WYOMING DEPARTMENT OF ENVIRONMENTAL QUALITY COMMENTS

Section 1.3 of the Draft Environmental Assessment (The Proposed Actions)

Figure 1. Water Level Recovery at MW-109

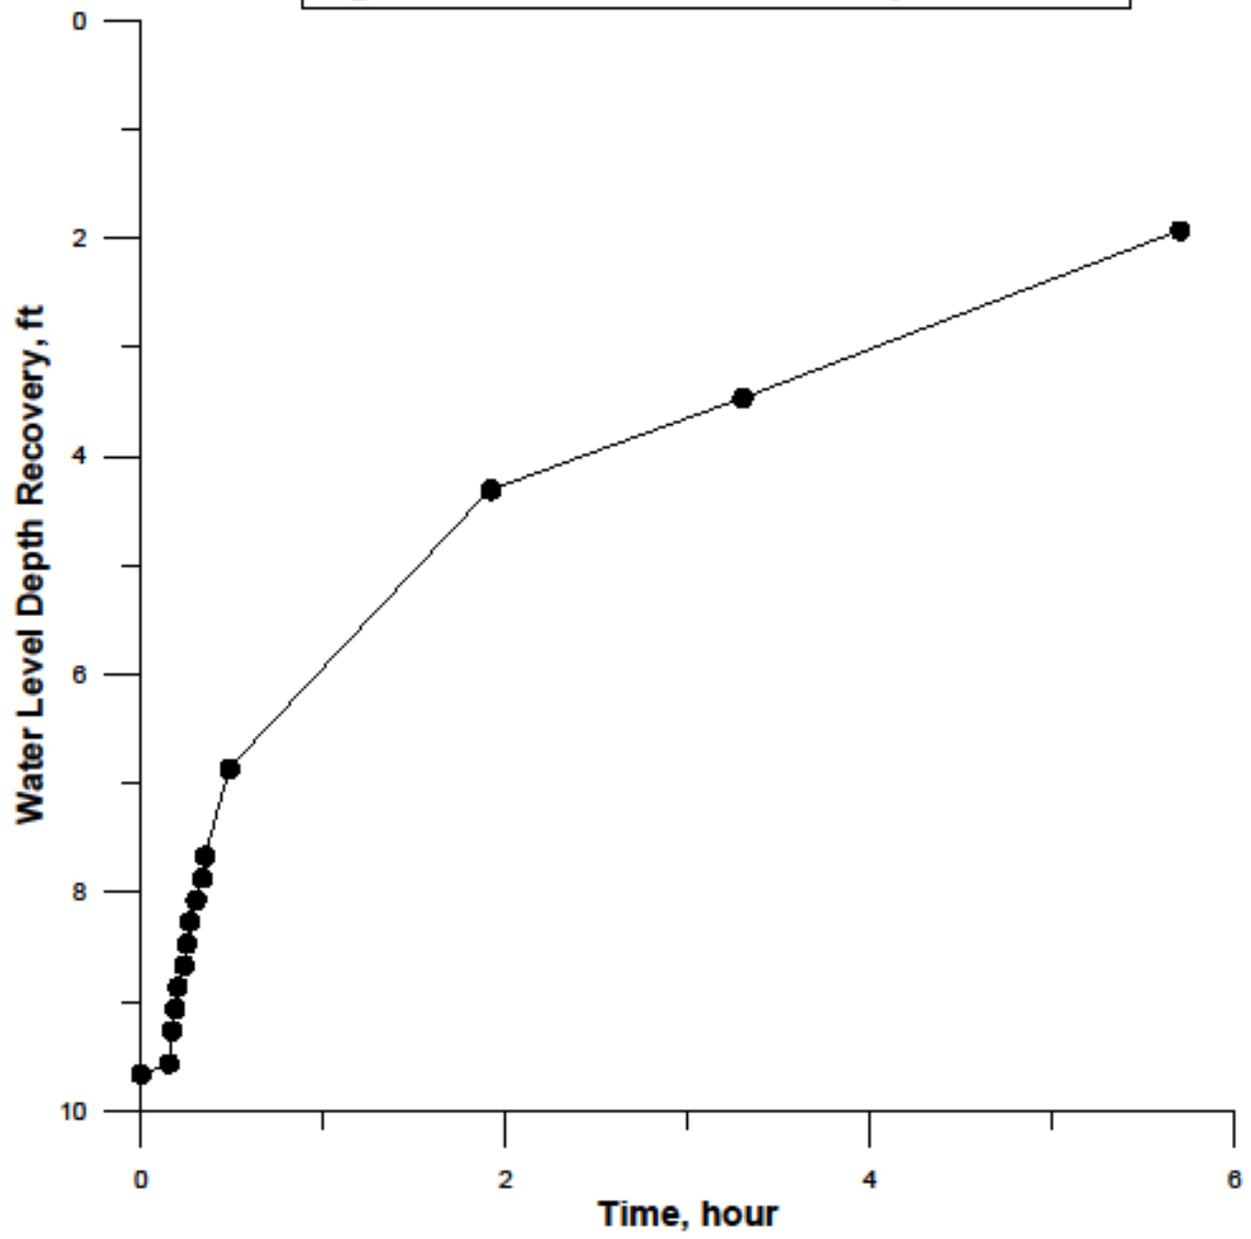
Comment 2. The results from the current fate and transport modeling are not valid. Fate and transport modeling should be applied to demonstrate that the predicted concentrations of these contaminants at the proposed POE wells does not exceed their respective Federal SDWA [Safe Drinking Water Act] MCLs (or State standards), or baseline concentrations (at the POE wells), whichever is greatest. Contaminant limits at the POE wells should adhere to Federal SDWA MCLs (or State standards), or baseline concentrations (at the POE wells), whichever is greatest. **(WQD)**

The constructed fate and transport model has captured essential features of the site, including subsurface geology and geochemical processes. As with any model, it has its limitations. The modeling results have been hindered by the extreme complexities associated with spatial variability. The model results at the proposed POE well MW-109 indicate that uranium concentrations are overestimated with a peak of 460 pCi/L. NRC asked the licensee to review the modeled value for POE well MW-109 and submit revised model results that more accurately reflect the measured values. In September 2012, the licensee, through its contractor Tetra Tech Geo (see ML12270A289), submitted revised predictions of uranium concentrations along Lang Draw which show a much better fit for POE well MW-109 when compared to measured values.

The measured values of uranium in well MW-109 from 2002 to 2012 are listed below.

The background water quality for uranium was established in well No. MW-9 to be 98.7 pCi/l (NRC, 1996, TER to establish background–ML12270A290). In order to demonstrate that the selection of well MW-9 as a background well is valid, the licensee determined the variation trends for “mobile species” through the time period from 1988 to 1995. The “mobile species” are pH, conductivity, total dissolved solids, chloride, and sulfate. In March 1993, total dissolved solids, chloride, and sulfate increased while prior to this date the “mobile species” were stable. Consequently, the licensee excluded data collected after March 1992 and established background for hazardous constituent concentrations as the mean plus two standard deviations. The NRC reviewer also noted that the ground water in the N-sands is naturally brackish and would be restricted to raising livestock.

The estimated level of risk using the overestimated concentrations at the POE well MW-109 is on the order of 10^{-4} , similar to the background risk for the site, and is acceptable under NUREG-1620, Rev.1 (NRC, 2003). Under 10 CFR Part 40, Appendix A, Criterion 5(B)(6), the NRC will establish site specific alternative concentration limits if it finds that the limits proposed by the licensee are as low as reasonably achievable and that there is not a substantial present or potential hazard to human health or the environment as long as the alternative concentration limits are not exceeded. The NRC is not required to compare contaminant values at a POE well to Federal or State ground water quality standards when making determinations under Criterion 5(B)(6). NRC staff has determined that the proposed ACLs for the site meet Criterion 5B(6) of 10 CFR Part 40 Appendix A.
